Subject: Bid Package #1
Borel Middle School HVAC Replcmt-DSA 01-119557
College Park Elementary School HVAC Replcmt-DSA 01 119530
Meadow Heights Elementary School HVAC Replcmt DSA 01-119554
North Shoreview Montessori School HVAC Replcmt DSA 01-119526
San Mateo - Foster City School District

ADDENDUM NO. 1

Subject: Borel Middle School HVAC Replacement
San Mateo - Foster City School District
Aedis Project No. 2021005
DSA Application #01-119557

ADDENDUM NO. 1

DATE 11/24/2021
JOB # 2021005.01
SHEET # AD1-
A2.01

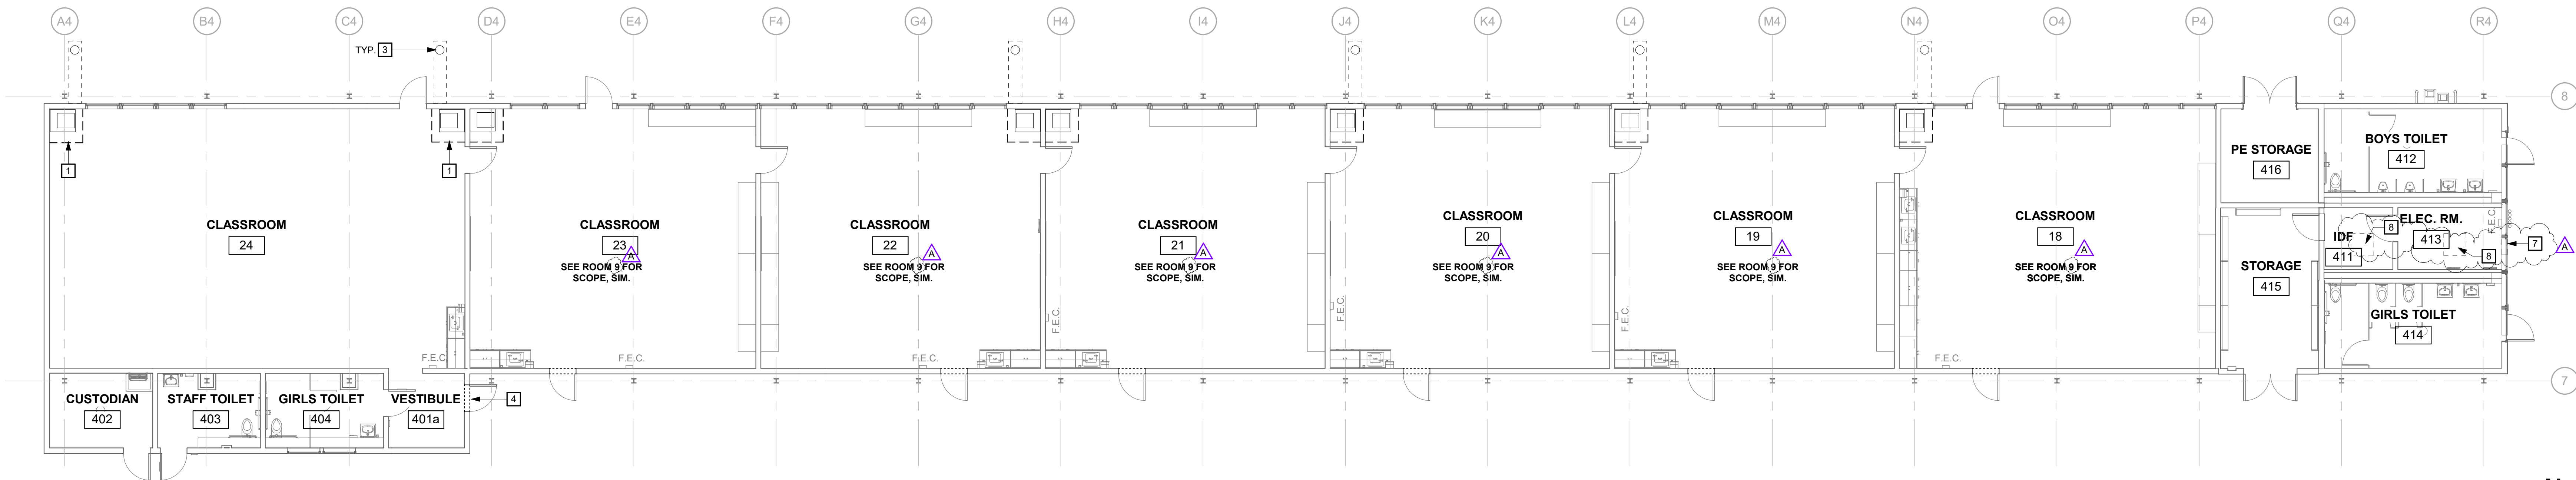
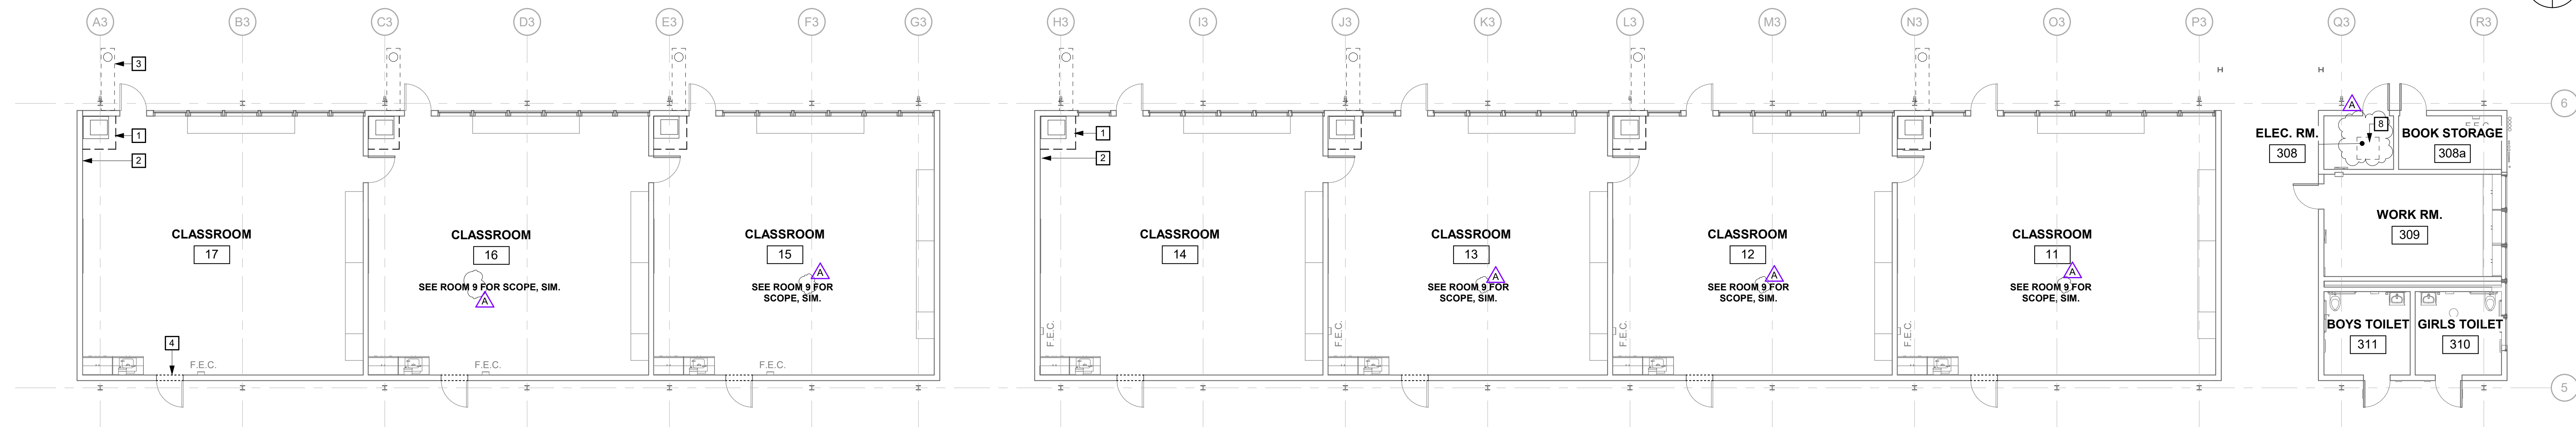
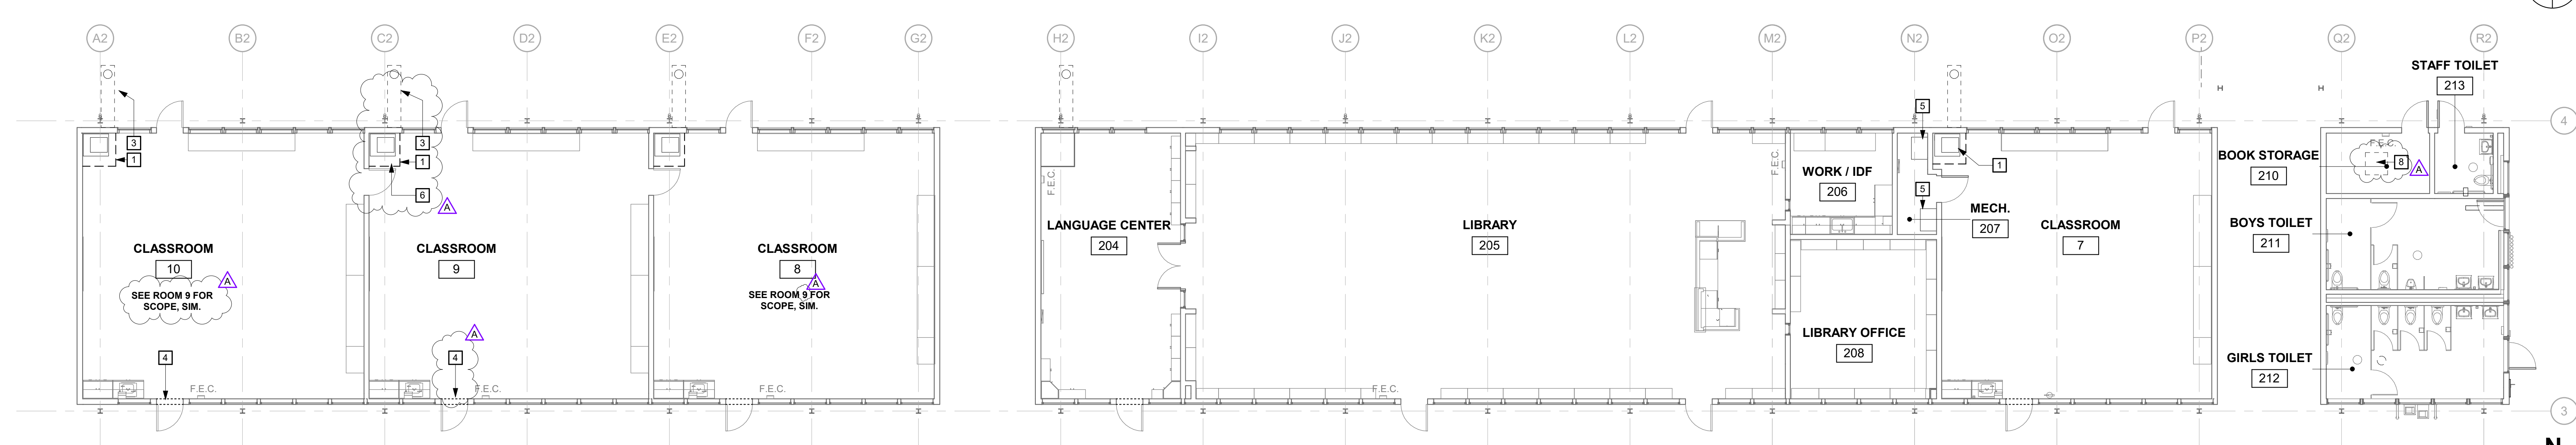
- Add: General Sheet Note #J per AD1-A2.01
- Add: Door stop keynote #6 to Demolition Floor Plans 1/A2.01, 2/A2.01 and 3/A2.01 per AD1-A2.01
- Add: Wall prep for louver keynote #7 to Demolition Floor Plan 1/A2.01 per AD1-A2.01
- Add: Partial ceiling demolition keynote #8 to Demolition Floor Plans 1/A2.01, 2/A2.01, and 3/A2.01 per AD1-A2.01
- Revise: Reference room 9 for similar scope where occurs in Demolition Floor Plans 1/A2.01, 2/A2.01, and 3/A2.01 per AD1-A2.01
- Revise: Demolition Floor Plan Keynote #4 per AD1-A2.01
- Add: View 4/A2.01 Partial Demolition Floor Plan – Wing 1 per AD1-A2.01
- Revise: Keynotes at rooms 9 and 10 in Demolition Floor Plan 3/A2.01 per AD1-A2.01

DATE 11/24/2021
JOB # 2021005.01
SHEET # AD1-
A3.01

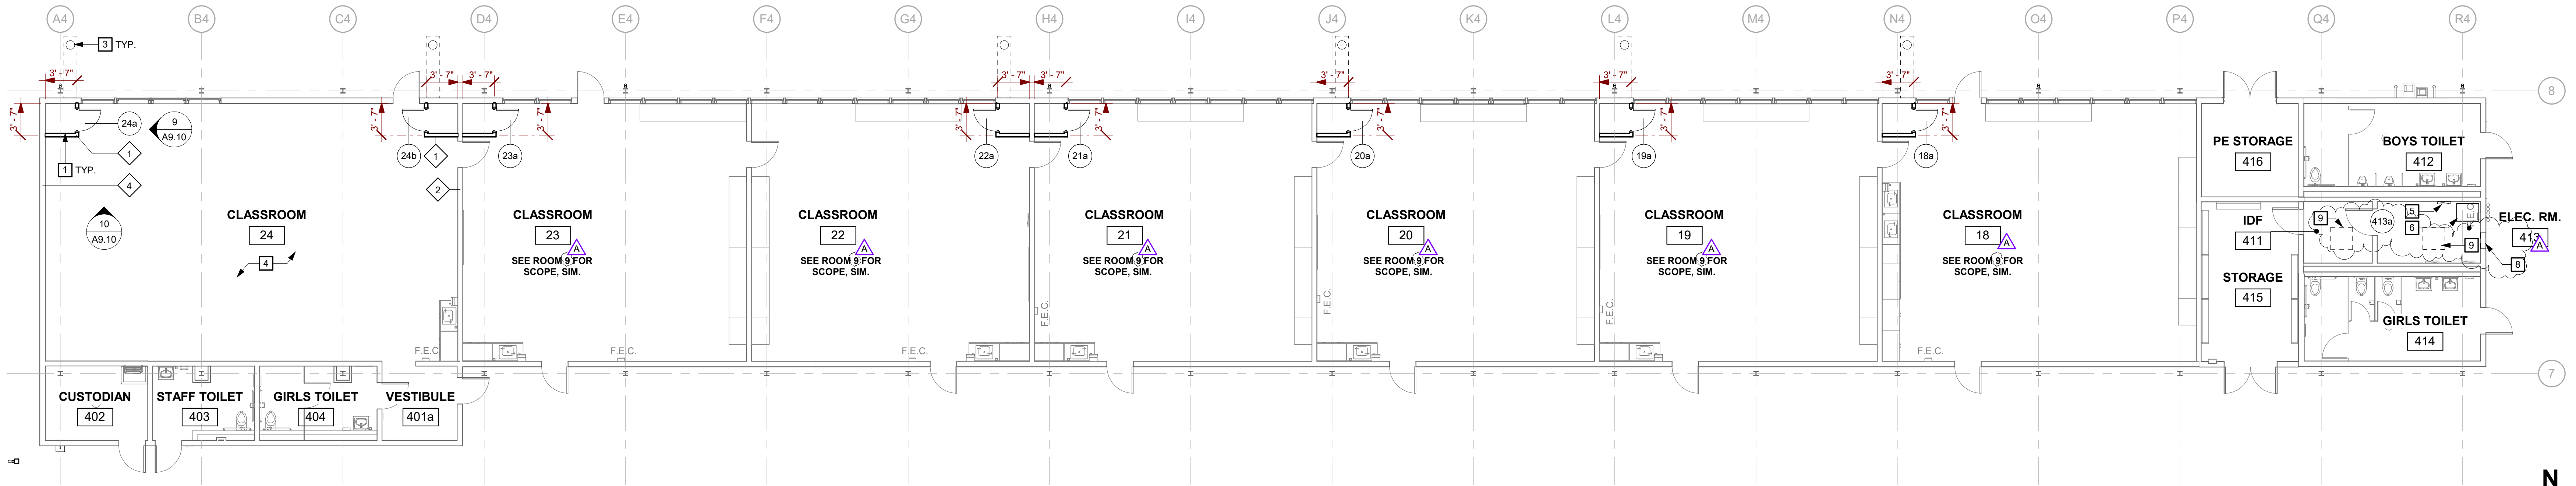
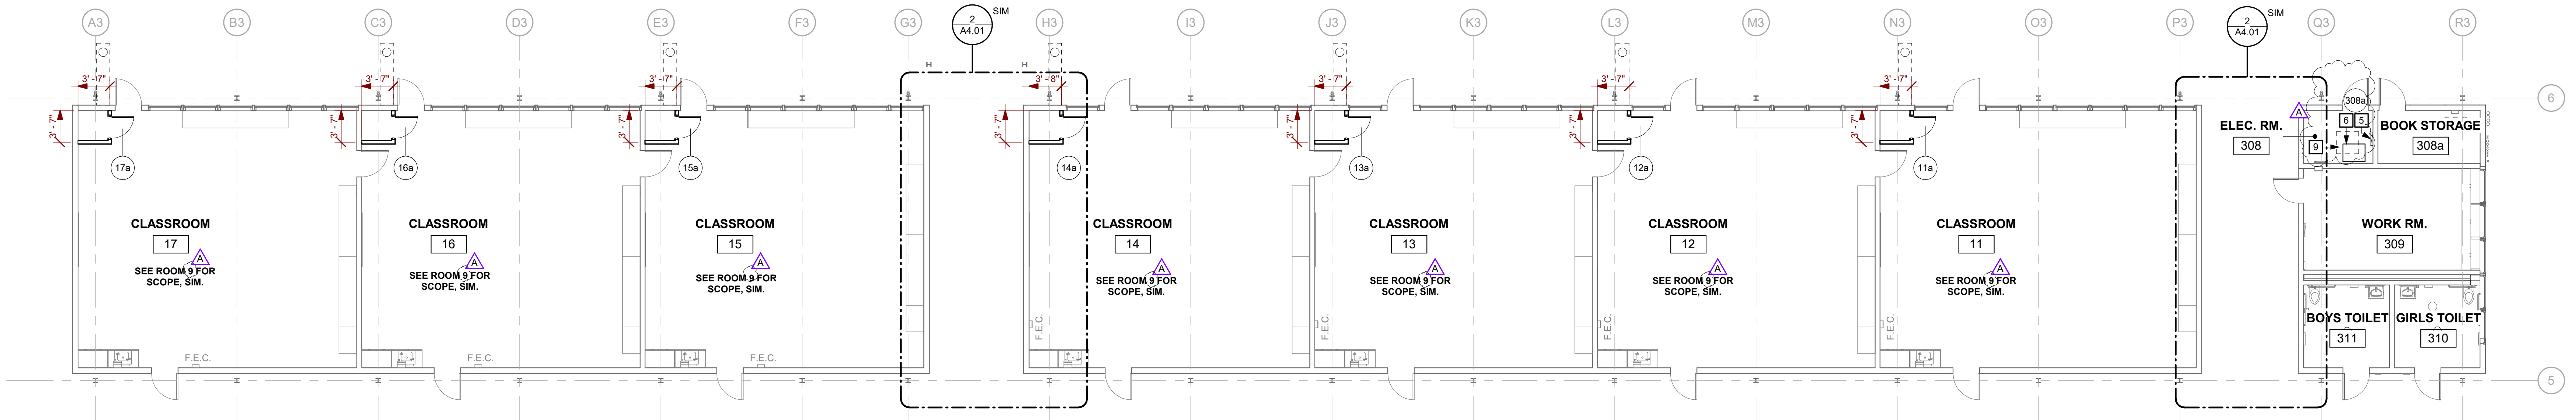
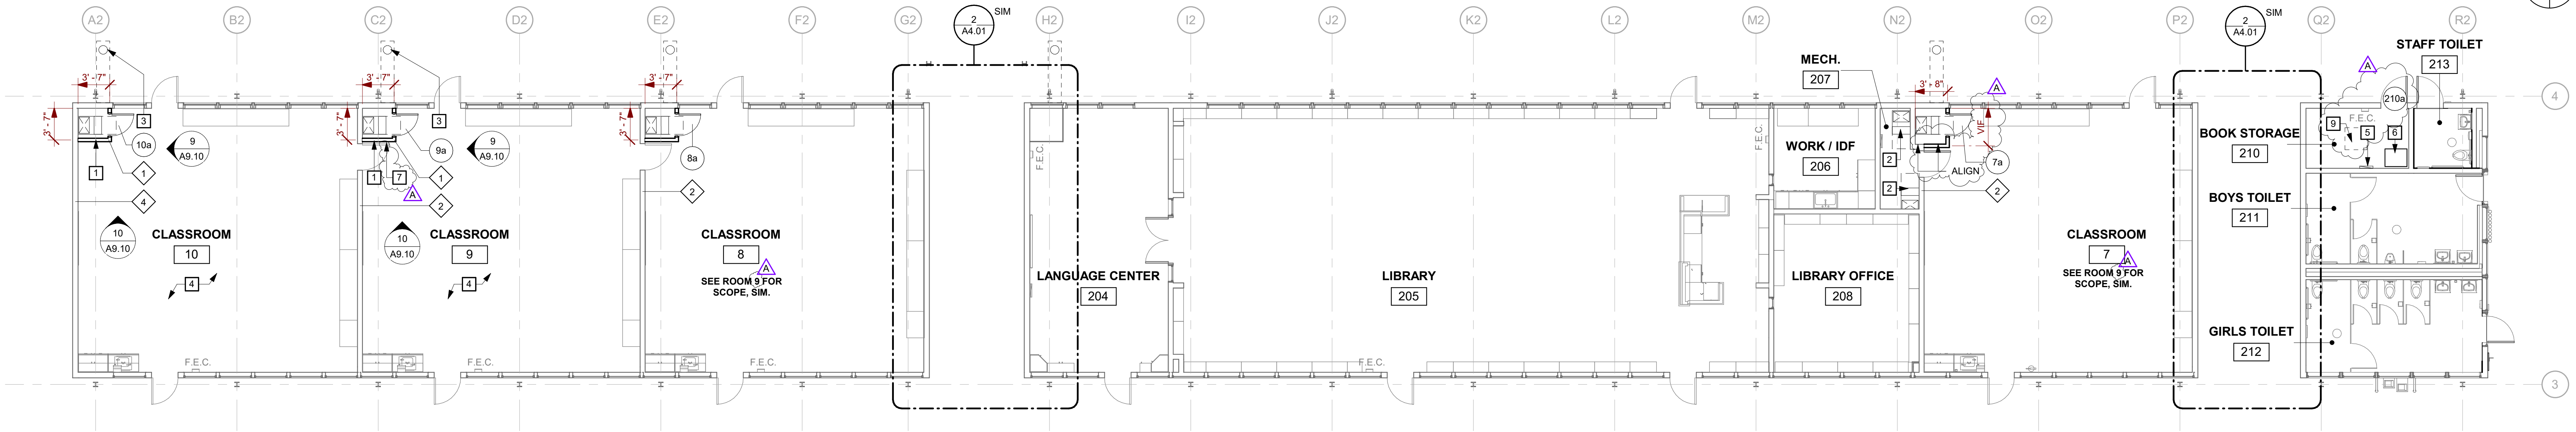
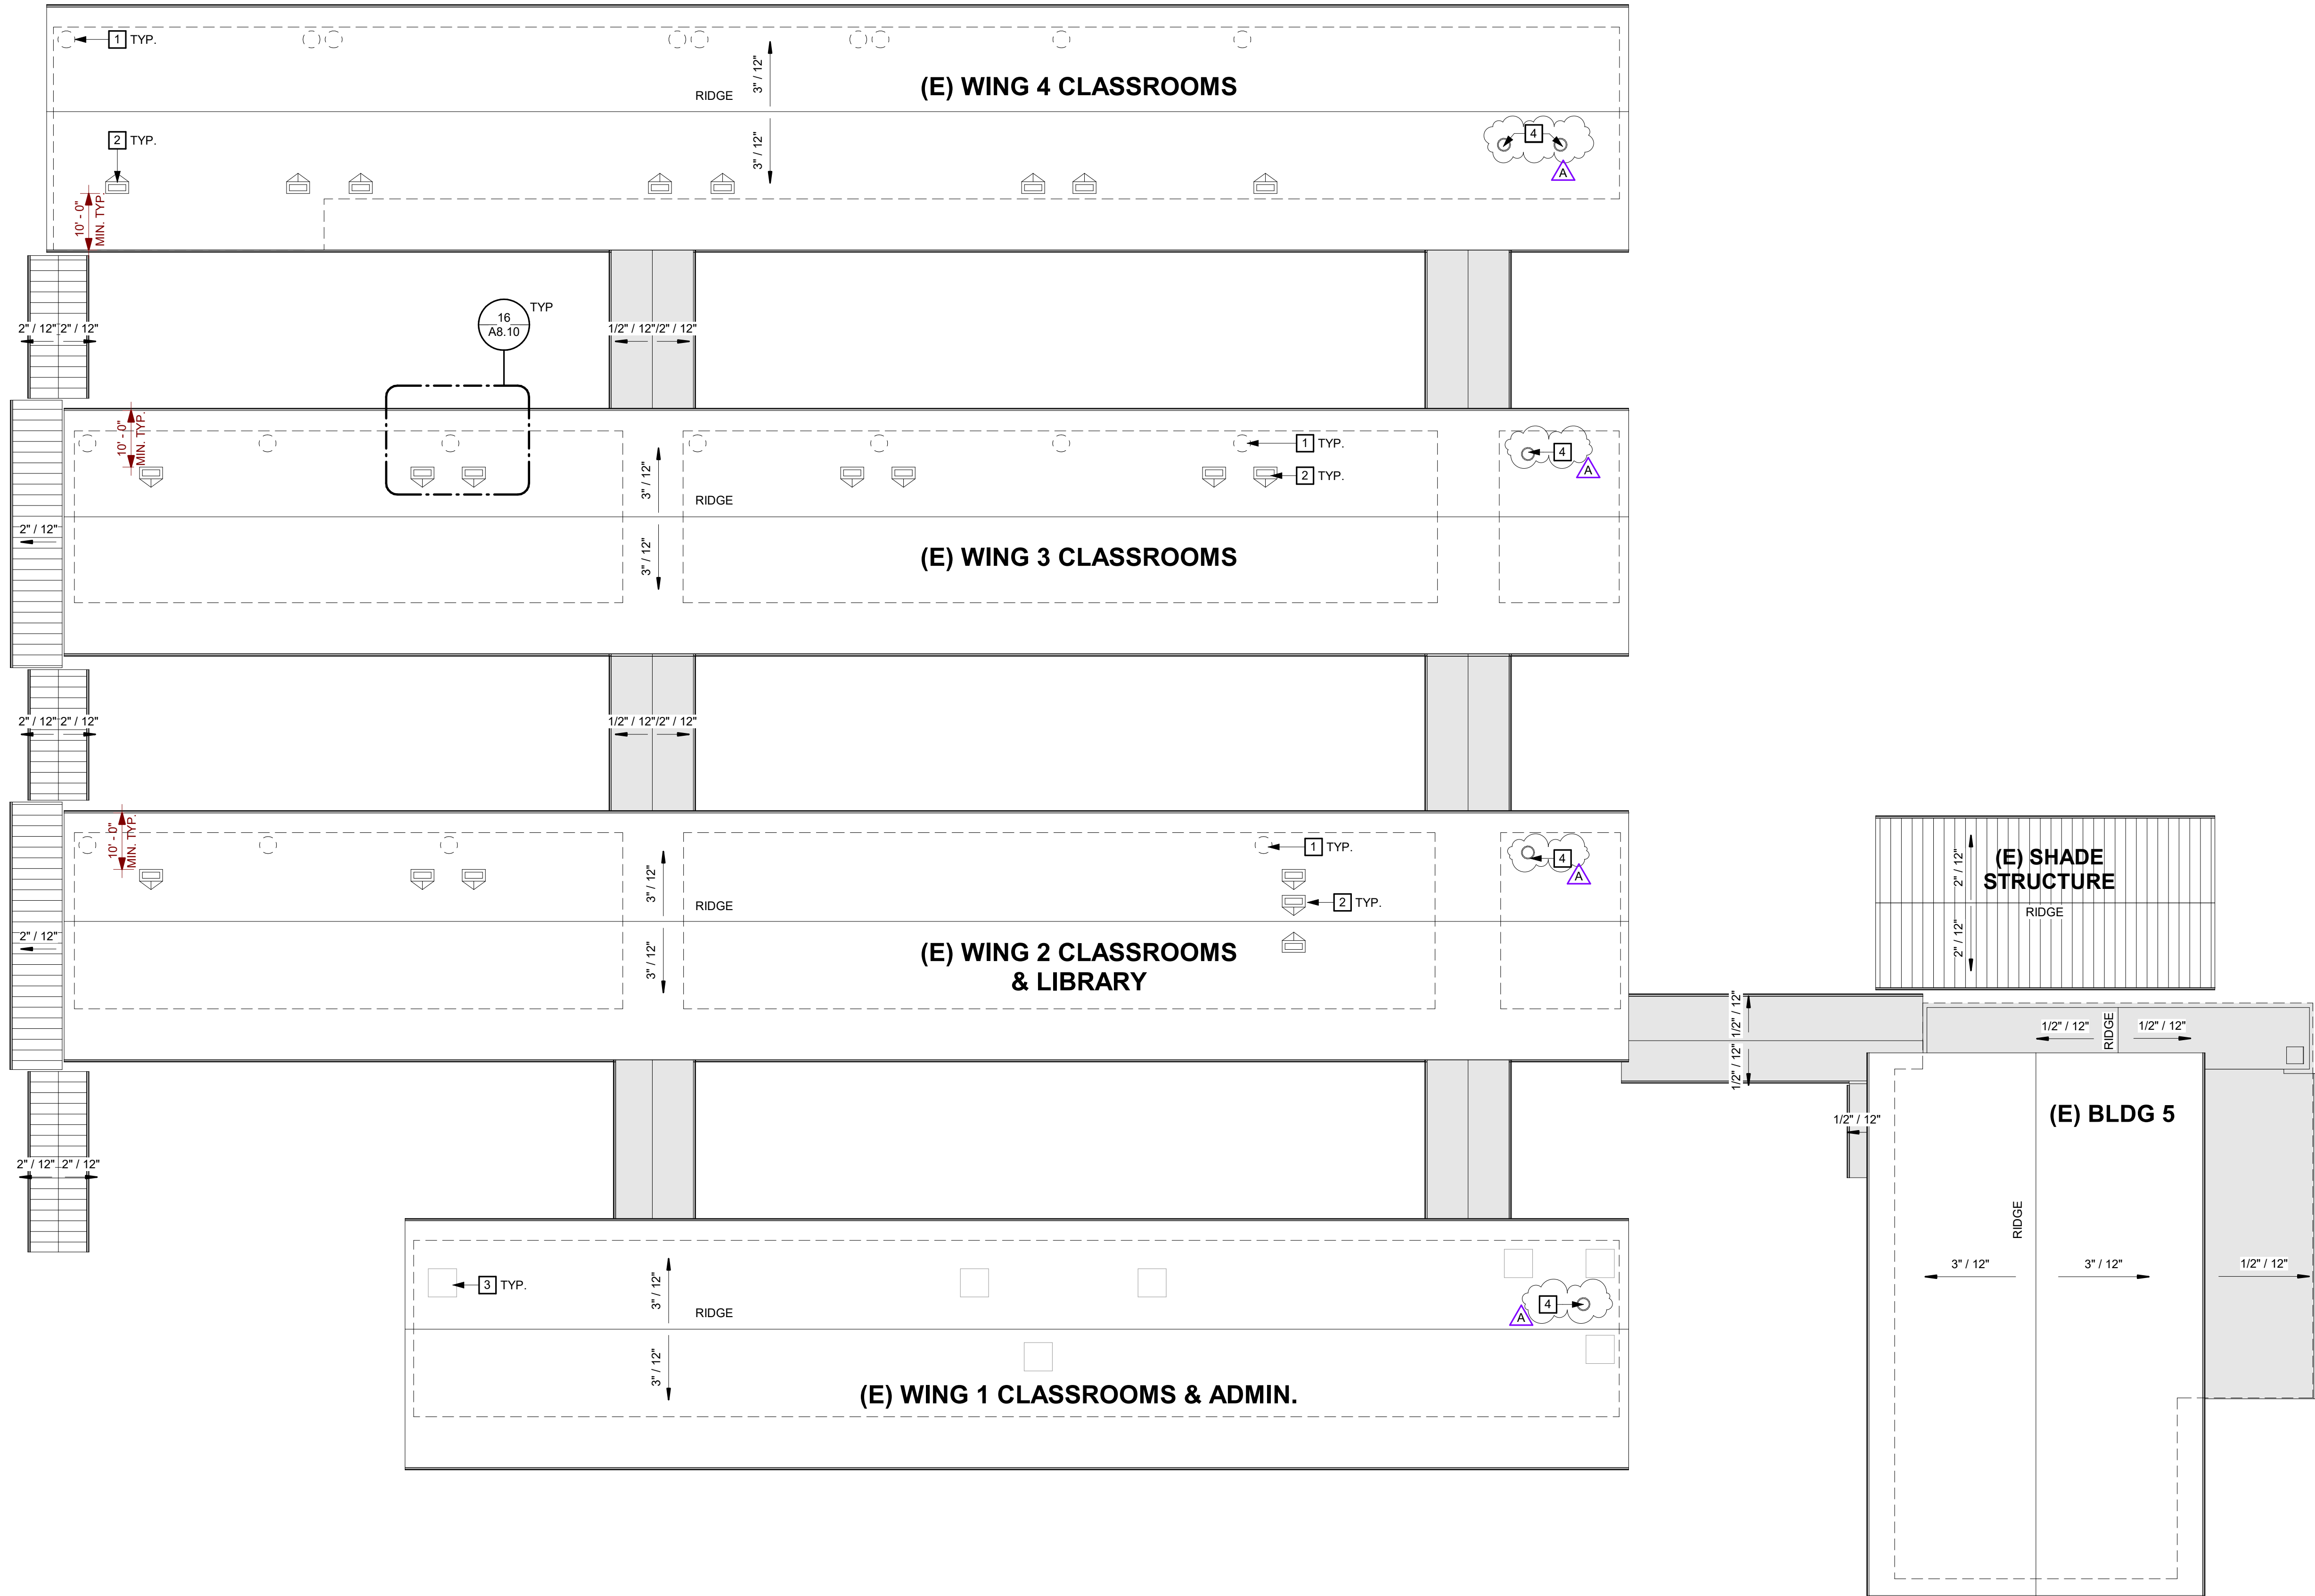
- Revise: Reference room 9 for similar scope where occurs in New Floor Plans 1/A3.01, 2/A3.01, and 3/A3.01 per AD1-A3.01
- Revise: Dimension and alignment at room 7 in New Floor Plan 3/A3.01 per AD1-A3.01
- Add: Door stop keynote #7 to New Floor Plans 1/A3.01, 2/A3.01, and 3/A3.01 per AD1-A3.01
- Add: New Floor Plan Keynotes #7, #8 & #9 per AD1-A3.01
- Add: Louver keynote #8 to New Floor Plan 1/A3.01 per AD1-A2.01
- Add: Ceiling patching keynote #9 in New Floor Plans 1/A3.01, 2/A3.01, and 3/A3.01 per AD1-A3.01
- Add: Door tags 210a, 308a & 413a in New Floor Plans 1/A3.01, 2/A3.01, and 3/A3.01 per AD1-A3.01
- Add: View 4/A3.01 Partial Floor Plan – Wing 1 per AD1-A3.01
- Revise: Keynote 4 per AD1-A3.01
